RE: PROPOSED AMENDMENTS TO APPROVED HAGA-HAGA WIND ENERGY FACILITY

A preliminary geotechnical report was prepared for the previously approved development by Outeniqua Geotechnical Services (OGS, 2017). The environmental consultant appointed by the developer for the proposed amendments, CES, has appointed OGS to review the original geotechnical report in light of the proposed revisions and provide comment on:

Figure 1: Proposed revised site layout showing positioning of 36 turbines

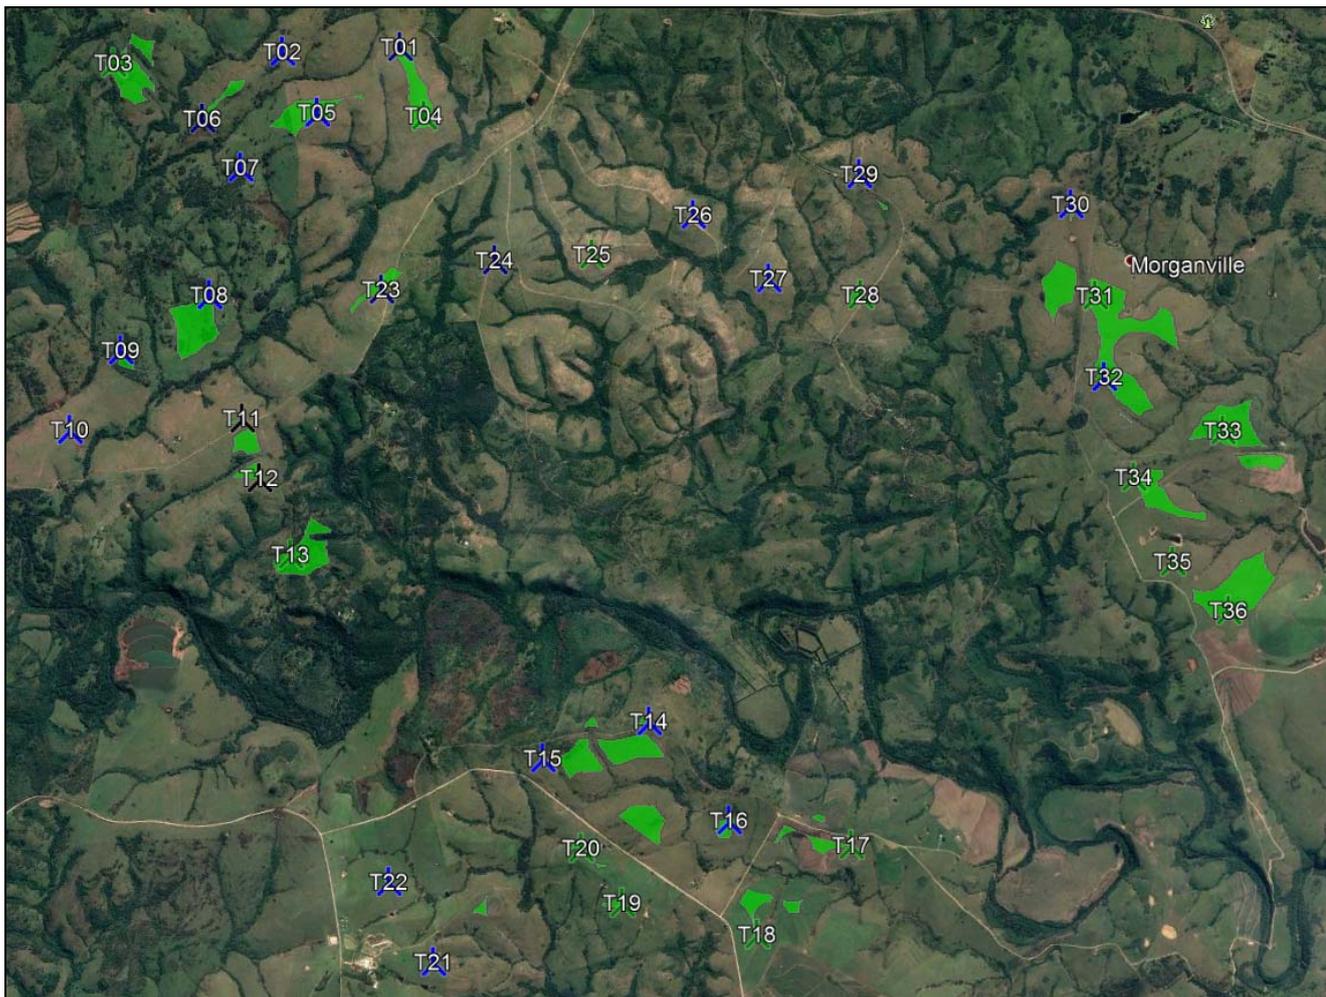
Subsequent to the granting of Environmental Authorisation (EA) for the proposed Haga Haga Wind Energy Facility (WEF) in the Eastern Cape Province, the developer has proposed some changes to the original turbine layout and specifications, as summarised in Table 1, and indicated in Figure 1.

Figure 2: New position T15a

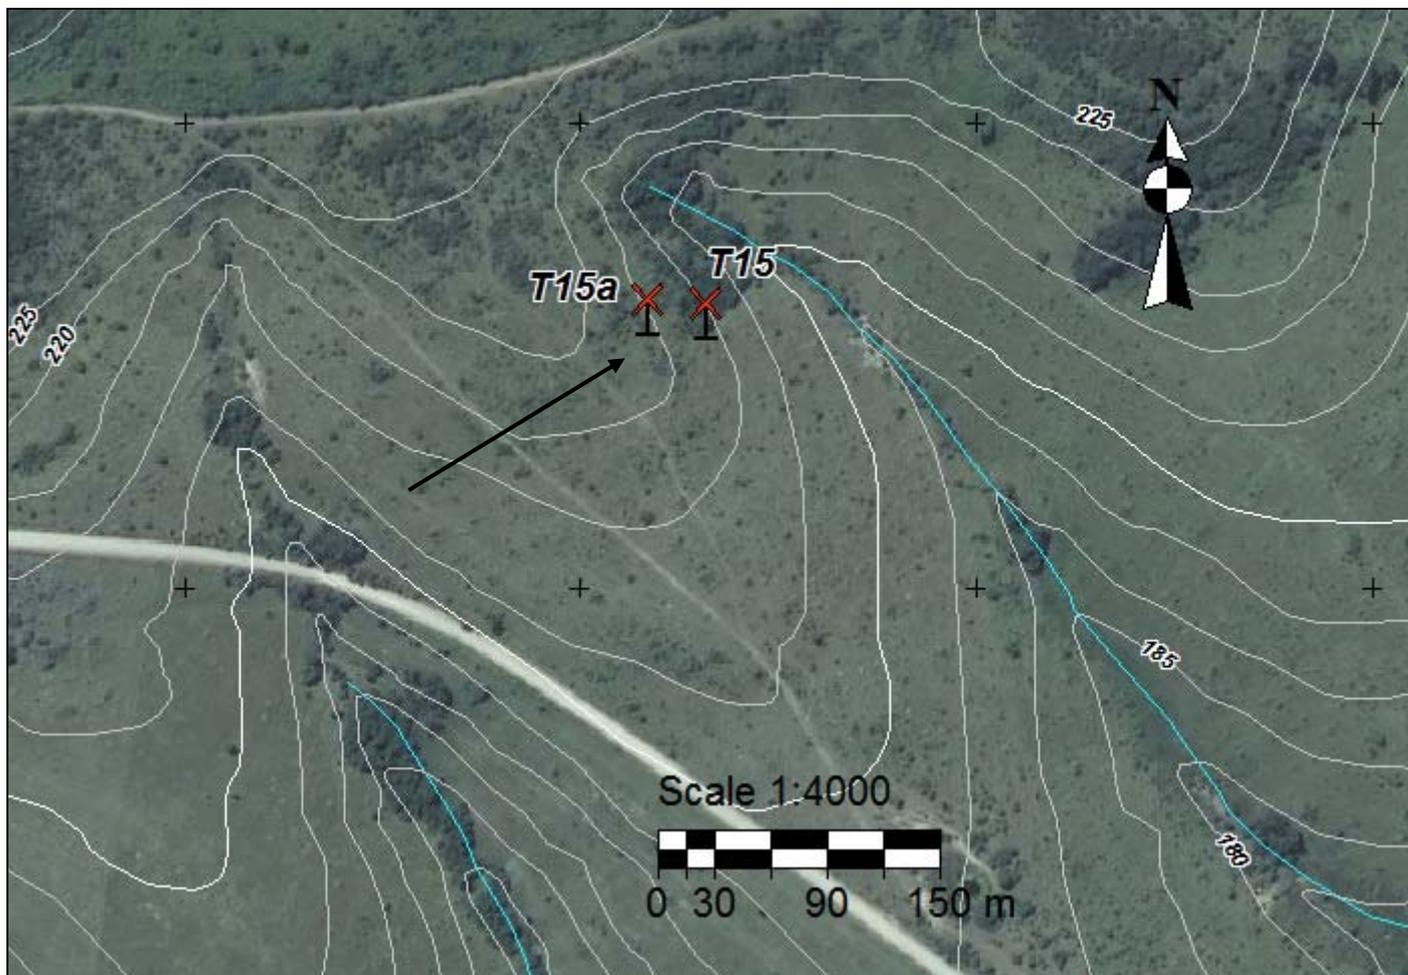
The proposed amendments of turbine positions within the identified buildable areas are generally suitable. Specific attention was drawn to the proposed turbine position T15, which was located on a moderate slope (estimated 1v:6h to 1v:4h) near a natural drainage line (see Fig 2). Following several discussions with the developer, this turbine was shifted slightly westward to a more suitable location further up the slope and away from the adjacent drainage line to a position outside the recommended 50m buffer zone. The turbine position remains on a moderate slope (1:6) and some engineering challenges may be encountered in the design, such as excessive cut-to-fill operations, erosion control, embankment stability, foundation design, etc. The turbine position is, however, suitable in terms of the environmental impacts. All other proposed turbine positions are deemed to be suitable with negligible additional impacts.
